Bulletin

MODEL BENTLEY MARK VI

CLUTCH PEDAL.

CLUTCH SLIP.For Information:

Fig.2. Section through flywheel.

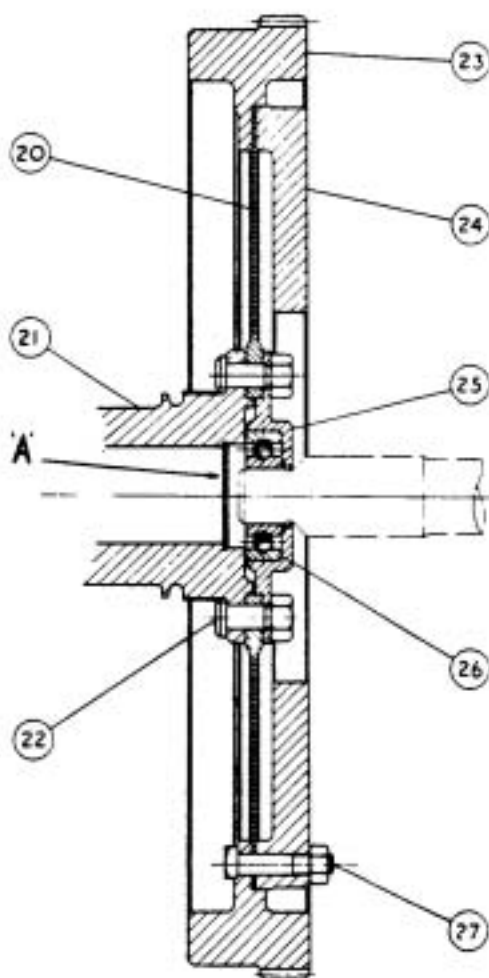
1. Oil leakage past the sealing washer 'A' Fig.2 at the rear end of the crankshaft.
2. Excessive initial loading of grease into the clutch spigot ball bearing (26 Fig.2) of the flywheel, distinguished by radial grease marks on the friction plate (24).
3. Over zealous application of the foot-operated chassis oil pump or a faulty oil restrictor (Type ZEO), allowing too much oil to reach the clutch release bearing (32 Fig.5) eventually working its way along the splines on to the driven plate.

It has been found on investigation, that under certain conditions there is a possibility of an oil leakage past the sealing washer ('A' Fig.2) at the rear end of the crankshaft. If the leakage is sufficient, oil may reach the front facing of the driven plate. In practice, it is likely that the first indication will be a clutch shudder and then a slipping clutch. If after removal of the clutch, oil, apart from grease, is found to be present in the spigot bearing (26 Fig.2), it can be assumed that it is leaking past the sealing washer.

Whenever there is evidence of oil leakage past the sealing washer, a rubber plug should be fitted as described herein. If however, a rubber plug is not immediately available, then it will be necessary to solder the sealing washer ('A' Fig.2) to the crankshaft as described in Paragraph 1b.

With the clutch removed from the flywheel, remove the crankcase lower half. Remove the nuts from the twelve bolts (22 Fig.2). Providing the nuts have not been over centre punched, it should be possible to use them again. Leaving the flywheel assembly in position on the crankshaft, remove the bearing housing (25) complete with the spigot bearing (26). Remove any surplus oil or grease from the spigot bearing and housing and do not add any additional oil or grease.

Fig. 3. Details of oil sealing plug.

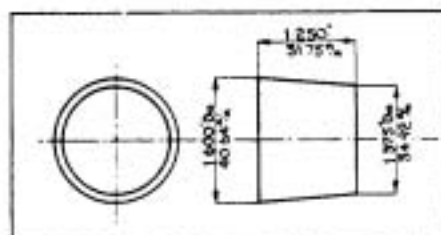
As a service rectification, a conical synthetic rubber oil sealing plug (Fig.3) has been introduced and is shown in position in the bore of No.7 crankshaft journal in Fig.4. Arrangements are being made for supplies of these plugs to be sent to all Overseas Retailers. Will Retailers in the U.K. kindly note that supplies are available from the London Service Depot.

With the clutch removed from the flywheel, remove the crankcase lower half, taking care to try and avoid damaging the Vellumoid joint fitted between the face of the crankcase and the wheelcase. Before fitting the rubber plug, it will be necessary to drill a $\frac{1}{16}$ " dia. (1.6 mm) air escape hole in the centre of the existing sealing washer. Prior to drilling, and to prevent any drilling swarf from dropping into the spigot bearing (26 Fig. 2), cut a piece of paper about $1\frac{1}{2}$ " (38 mm) wide, grease it on one side and then fold it in cylindrical form so that the greased side is on the interior, pass it through the spigot bearing and up to the face of the sealing washer. After drilling the washer, remove burrs from hole and then carefully remove the paper tube, together with all traces of swarf which will be found to be trapped on the greased side of the paper.

Fig.5. Section through clutch release bearing and trunnion.

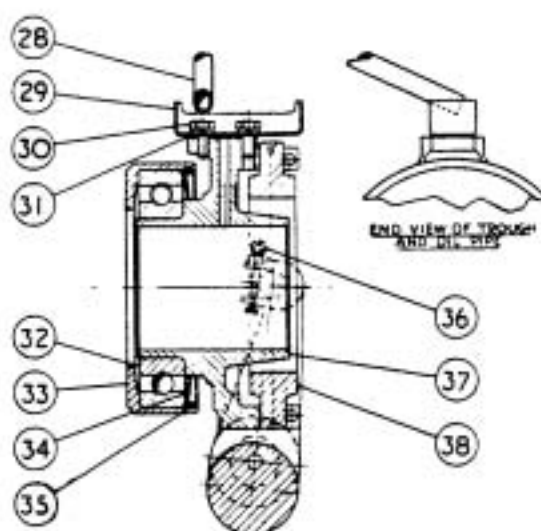
The above will probably allow too much oil to reach the clutch release bearing (32 Fig.5) and eventually find its way on the rear facing of the driven plate assembly. The chassis oil pump should only be operated in accordance with the instructions given in the Owners Handbook i.e. "Depress

If the clutch has been removed for the purpose of fitting a new driven plate assembly, then prior to refitting the gearbox to the clutch casing, ascertain that the oil feed pipe (28 Fig.5) to the oil trough of the clutch trunnion is correctly positioned above the trough. The end of the pipe should be approximately over the front setscrew (i.e. the one nearer to the flywheel) retaining the trough to the trunnion when the clutch release bearing housing (33) is in contact with the adjusting screws of the three clutch release levers. Check that the oil feed hole from trough to the trunnion is clear. With sufficient oil in the foot-operated oil pump, depress the pedal once and count the number of oil drops delivered to the trough of the trunnion.

Approximately three to five drops should be delivered with each application of the pedal. If either above or below this rate of flow, check the restrictor elbow situated on the right-hand top side of the clutch casing, by replacing with a new one of the same type (ZEO).

If the flow is still too great, then fit a type ZEOO elbow which will give a reduced rate of flow, conversely if there is still insufficient oil delivered, then check for a leakage or pipe breakage at some other point in the centralised chassis lubrication system.

FIG.1 FLYWHEEL AND PRESSURE PLATE - ORIGINAL DIMENSIONS.

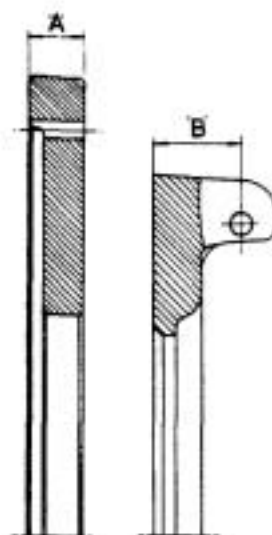
It is permissible to regrind the surface of both the flywheel friction plate and the clutch pressure plate should they show signs of scoring. Only the minimum amount of metal necessary to provide a clean, smooth surface should be removed. Grinding limits and original dimensions are given in Fig.1.

A surface grinder should be used and a Carborundum stone of grade BA80-N5-VBLU is recommended. The clutch pressure plate may be placed face downwards on the machine table and the backs of the lugs for the toggle levers lightly ground flat to provide a true surface. The plate may then be reversed and the face ground as required.

A flywheel friction plate that shows any sign of small, hair-line, contraction cracks should be discarded.
